**ENVIRONMENTAL STATEMENT –
Addendum, March 2026.**

**NUNEHAM SOLAR FARM – LAND WEST OF A4074, TO THE
NORTH-WEST OF NUNEHAM COURTENAY, SOUTH
OXFORDSHIRE.**

Date: 20/03/2026 | Pegasus Ref: P21-2947

DRAWING TITLE
FIGURE 8 TYPICAL PV MODULE AND RACK DETAILS

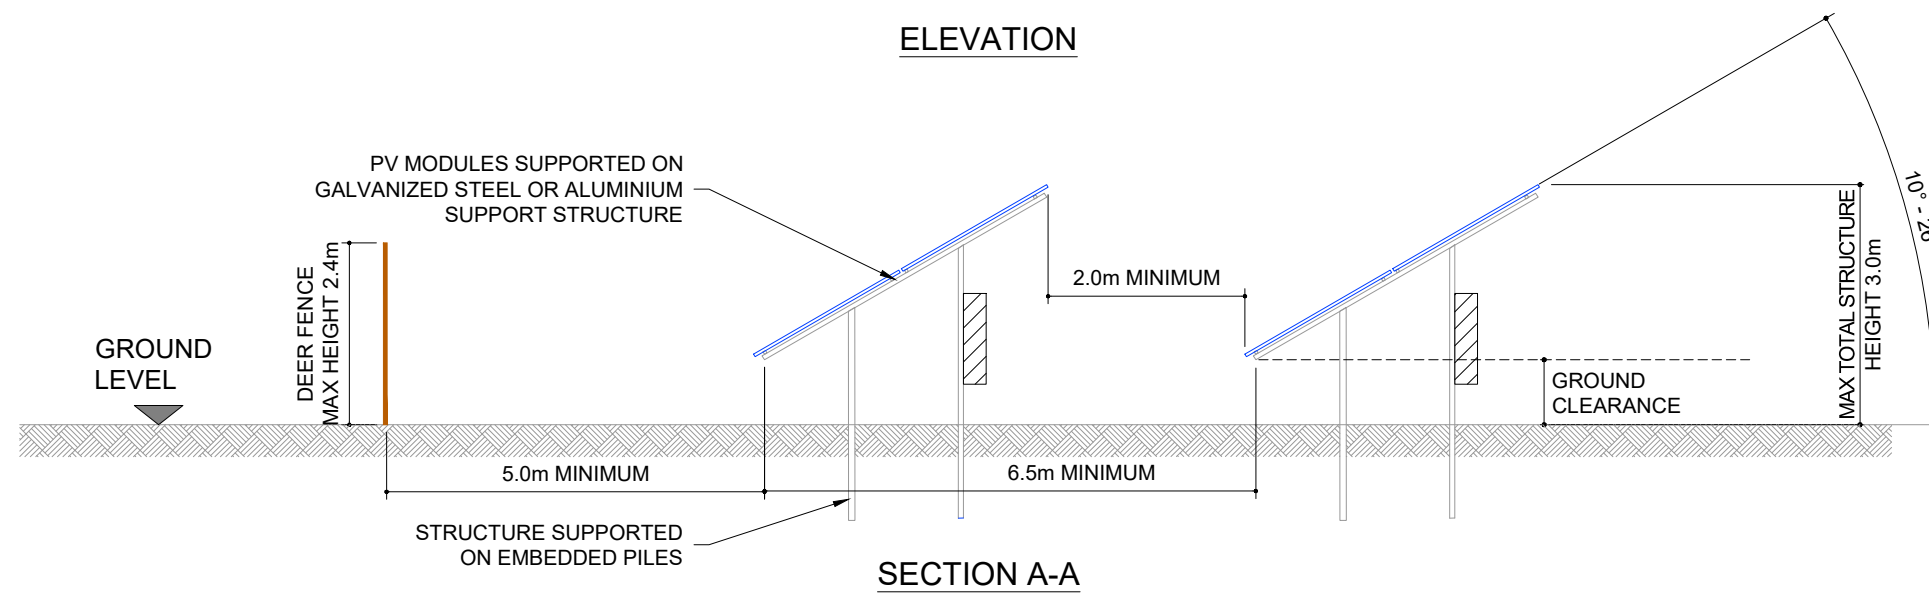
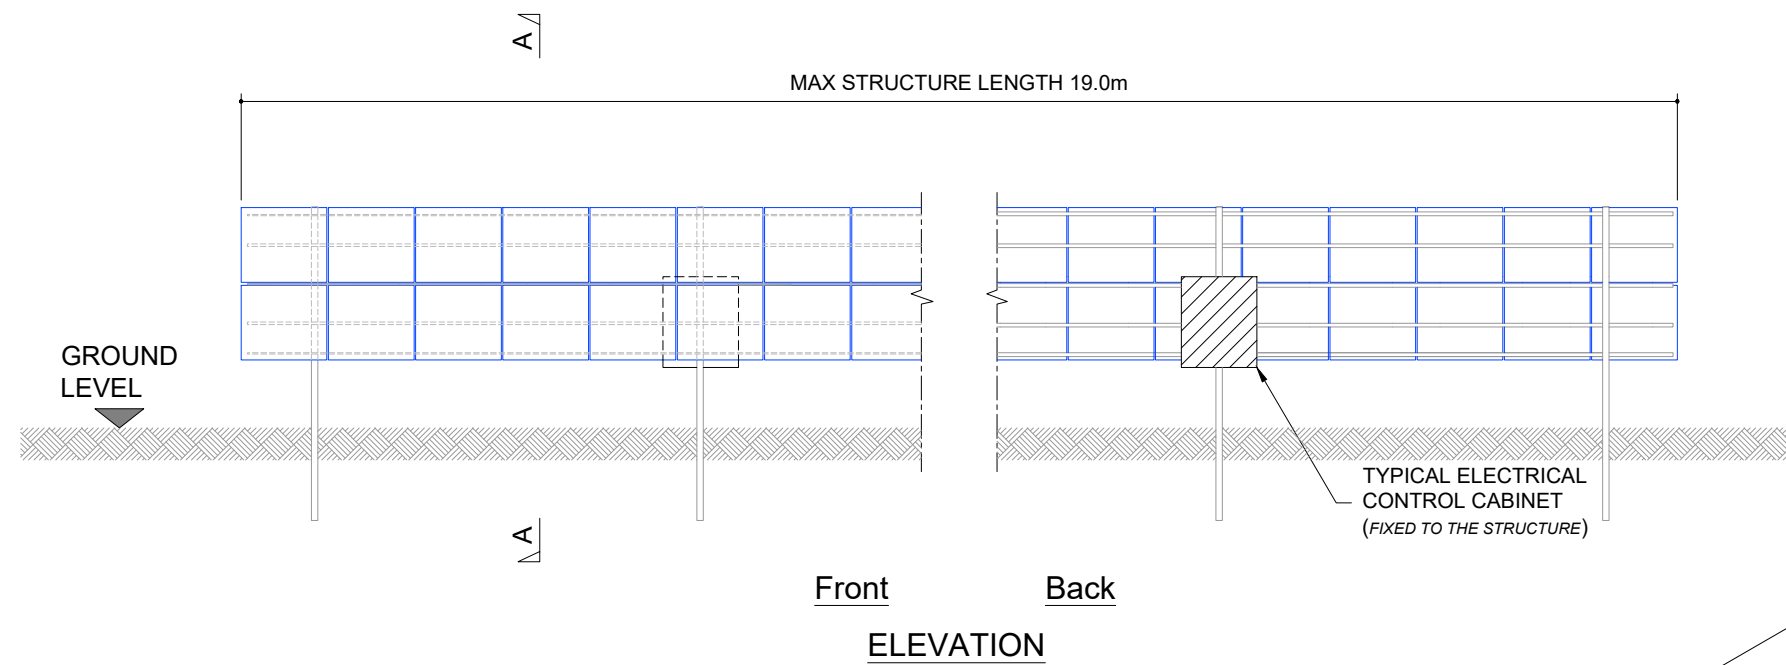
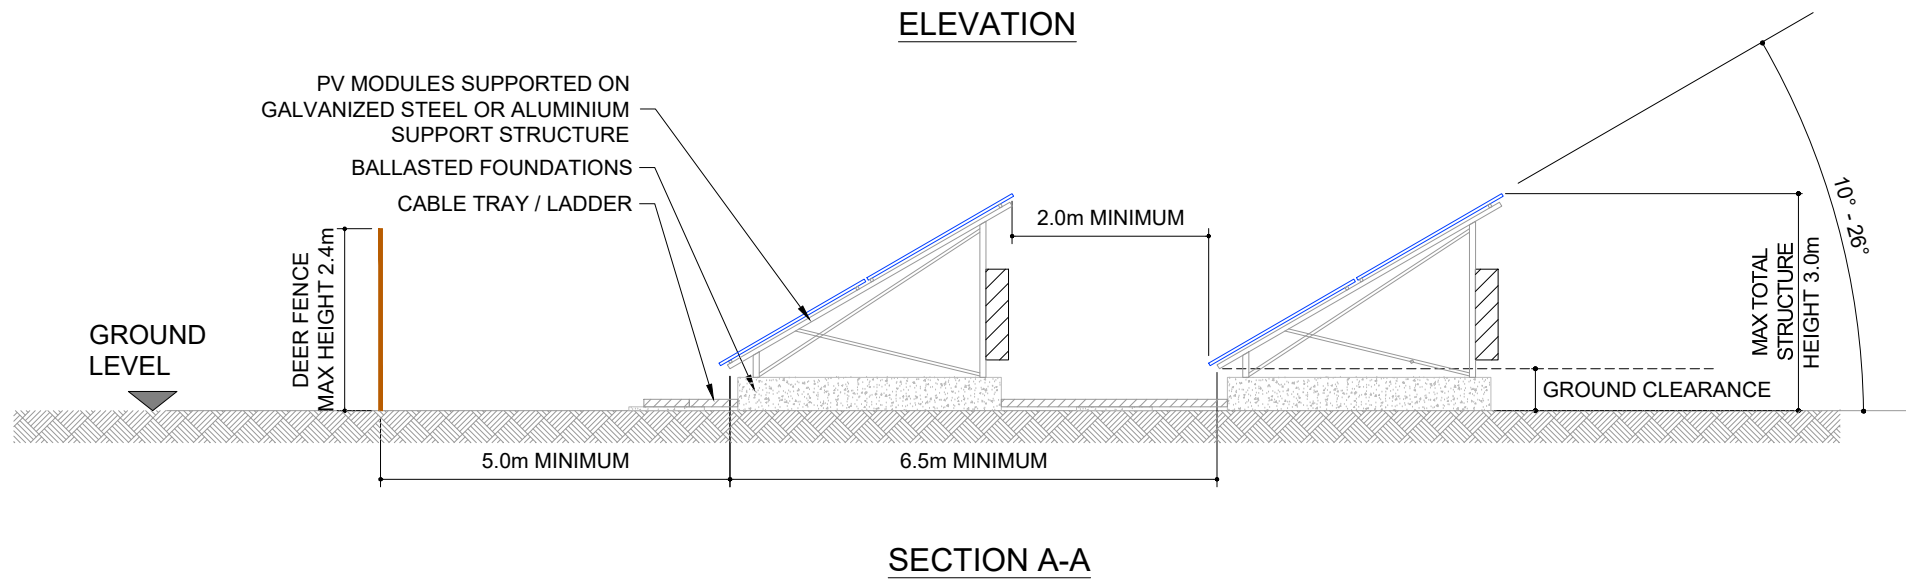
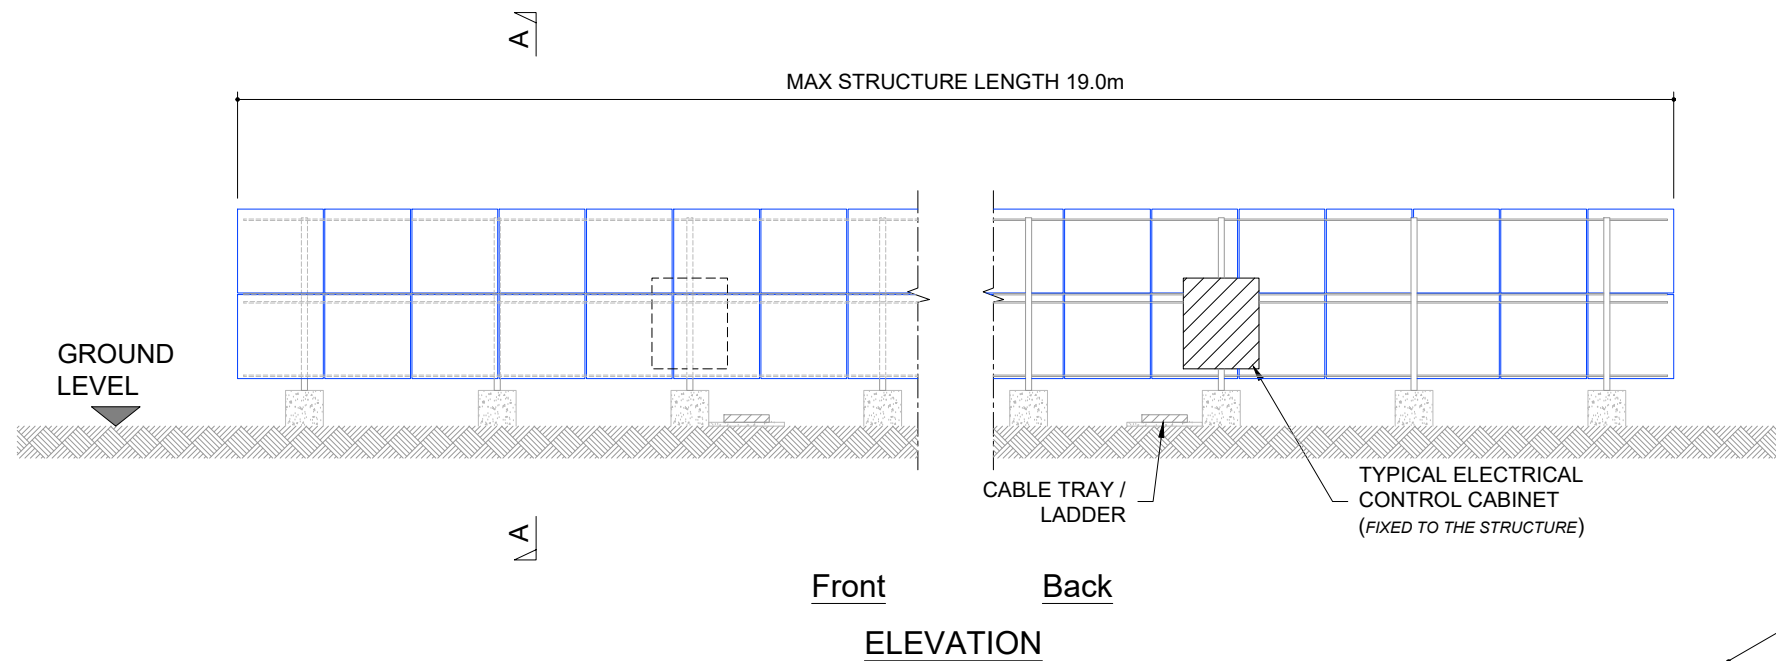
- **Reduction in panel height** – the panel height as currently submitted included for a maximum height of the panels to 3.6m (as shown on Figure 8 – 04531-RES-SOL-DR-PT-001 Rev 2 Sheets 1 & 2). As part of the revised scheme the panels have reduced in height to a maximum of 3m across the site. Drawing Number 04531-RES-SOL-DR-PT-001 Rev 3 Sheets 1 & 2 provides these revised details.

3	FG	JN	BD	2026-01-16	Max height, tilt angle amended
2	FG	IB	BD	2024-01-23	Minor update (PV image)
1	FG	IB	BD	2023-06-02	First Issue

3	FG	JN	BD	2026-01-16	Max height, tilt angle amended
2	FG	IB	BD	2024-01-23	Minor update (PV image)
1	FG	IB	BD	2023-06-02	First Issue

FIGURE 15 ENVIRONMENTAL STATEMENT INFRASTRUCTURE LAYOUT

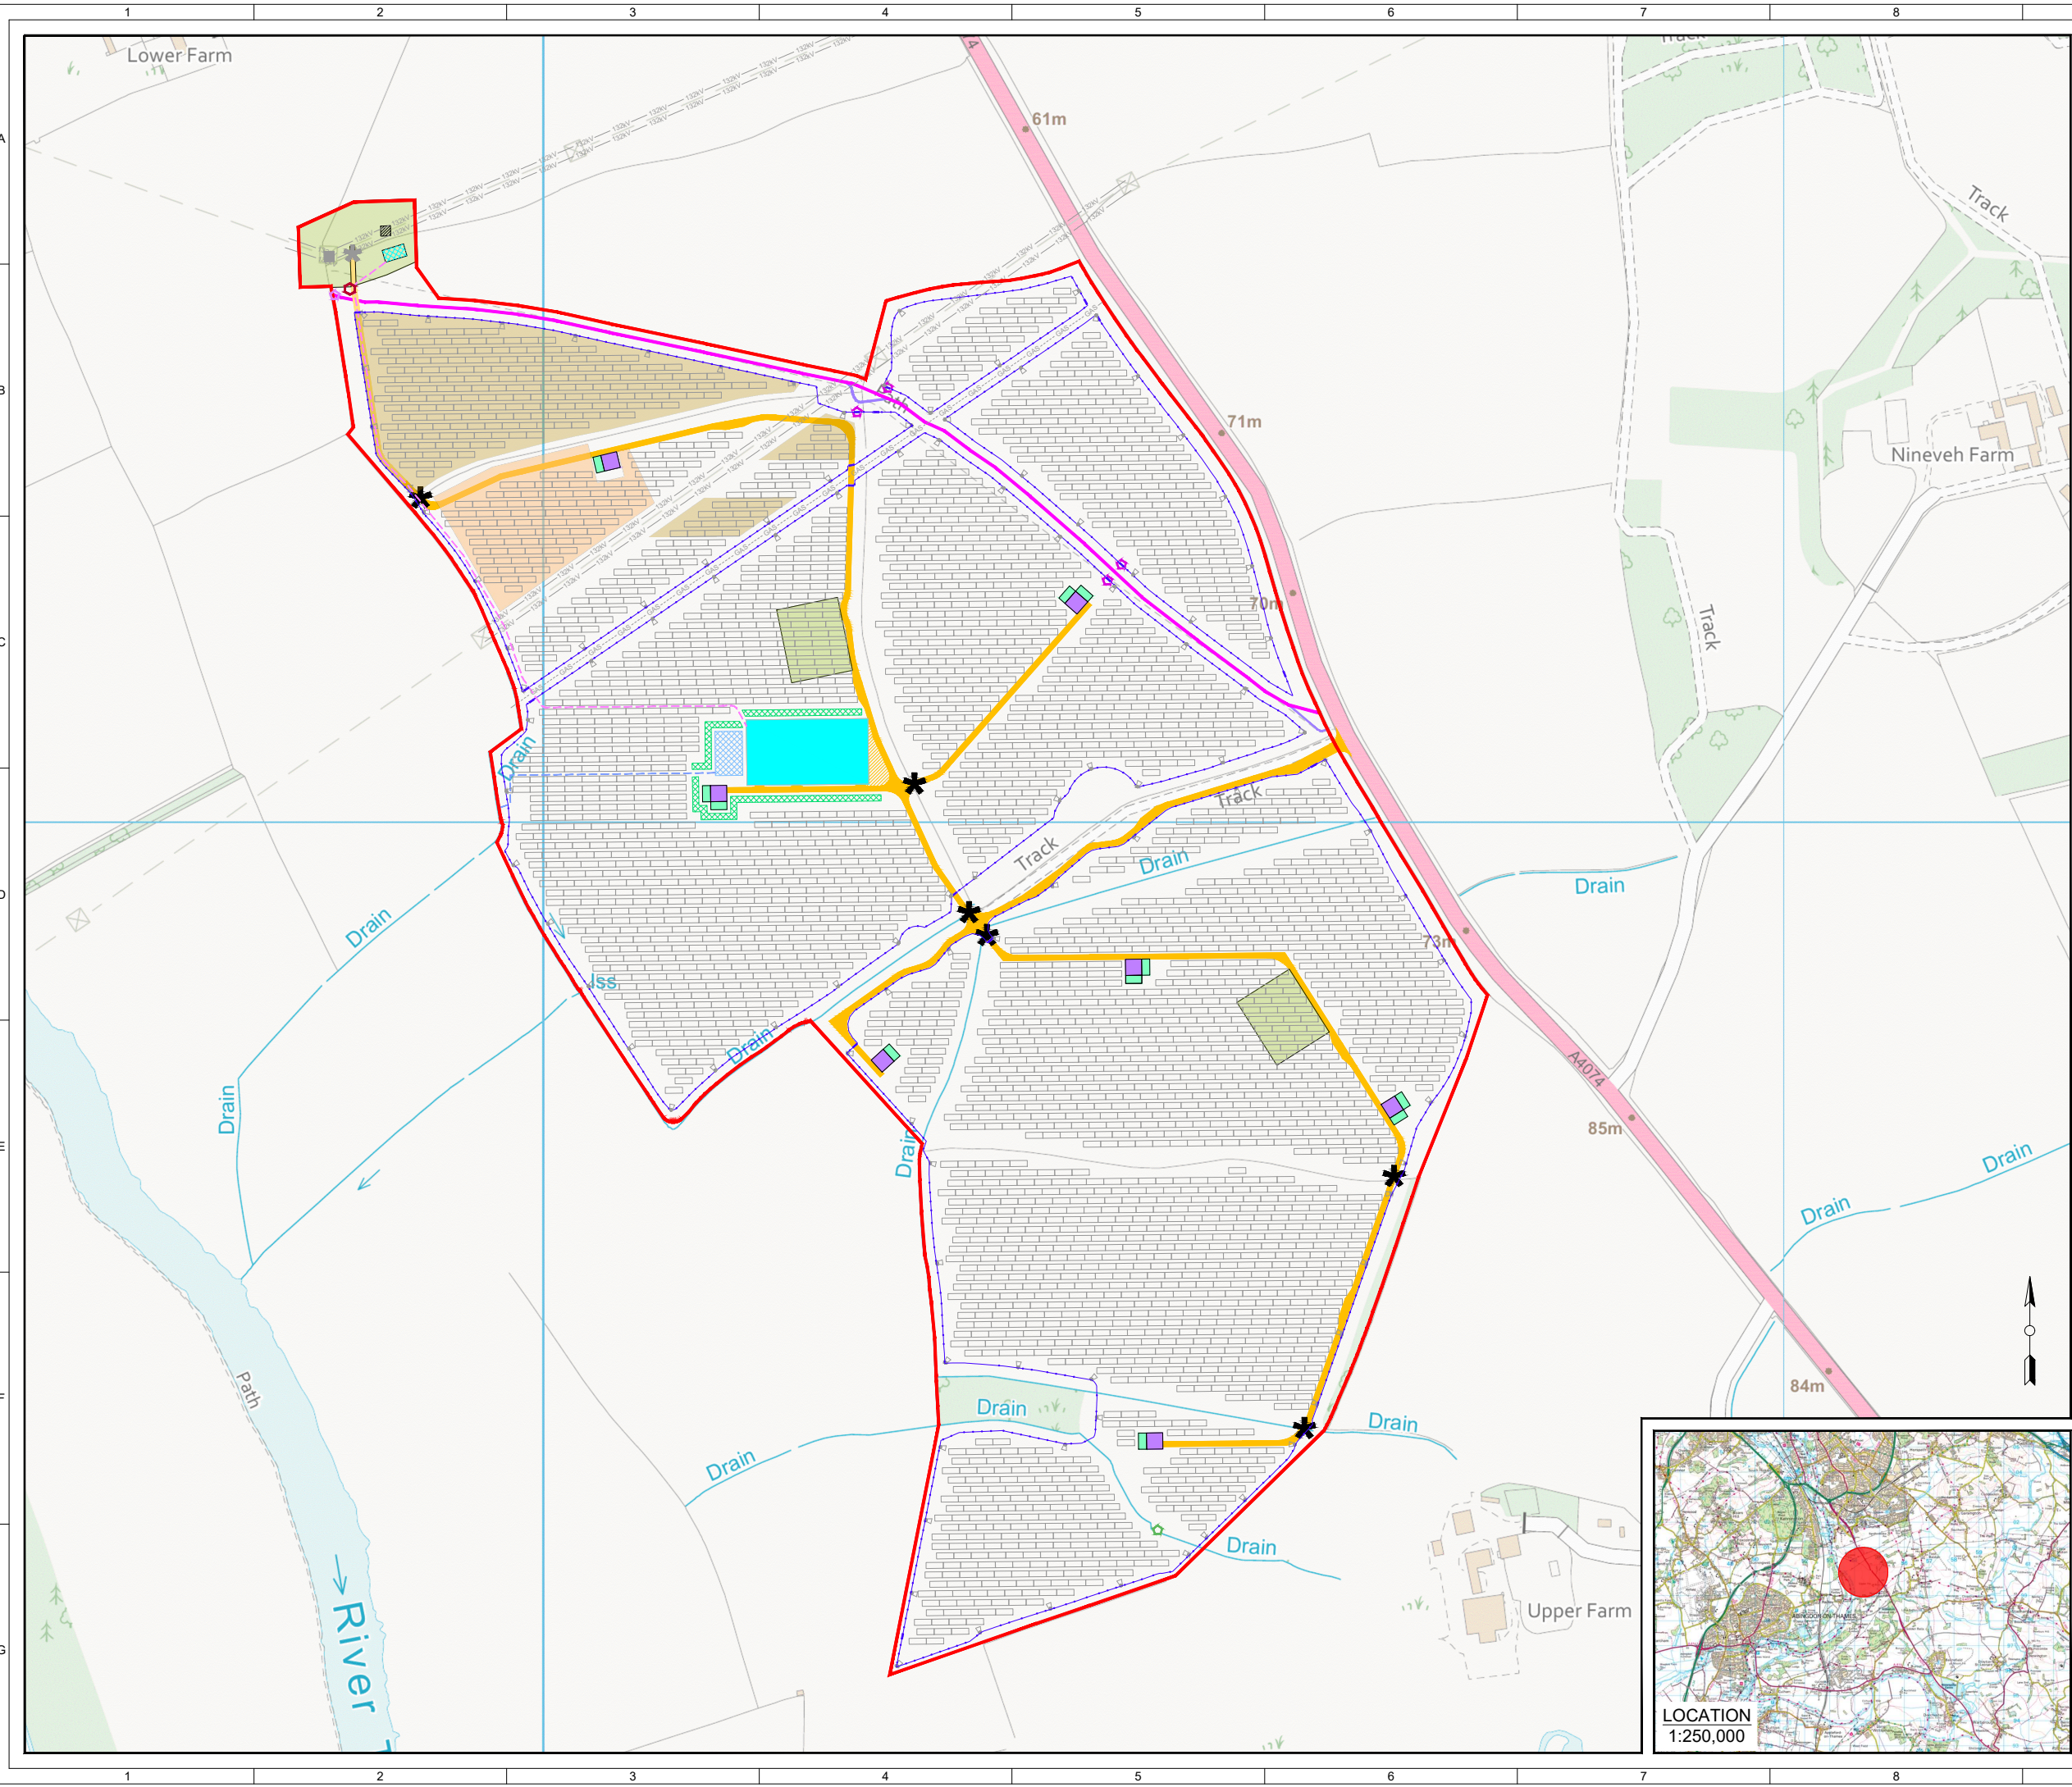
15. In this meeting the revised location was proposed, discussed and agreed. As such, the following changes have been made to the layout:
 - **Relocation of Substation Building** – the substation has been relocated within the site to an area of lesser archaeological potential. This has been accepted by the County Archaeologist and Conservation Officer informally prior to submission. The area in which the substation was previously sited will be covered by panels and a no dig approach to construction maintained. Works associated with the substation are provided on the submitted plans, the substation itself has not increased in area of the site covered.

16. The original solar farm proposals were shown on Environmental Statement Figure 3.1 – ‘Environmental Statement Infrastructure Layout’. This plan has now been superseded by an updated version which is included with this Addendum (Drawing Number 04531-RES-LAY-DR-PT-006 Rev 4).

4	FG	BD	BD	2026-01-26	Substation location updated
3	FG	BD	EB	2024-03-11	Minor amendments (Indicative heritage added, key update)
2	FG	JM	BD	2024-03-04	Minor amendments (OHL constraint buffer update)
1	FG	JM	BD	2024-01-18	First Issue
ISSUE DRAWN	CHKD	APPD	DATE	REVISION NOTES
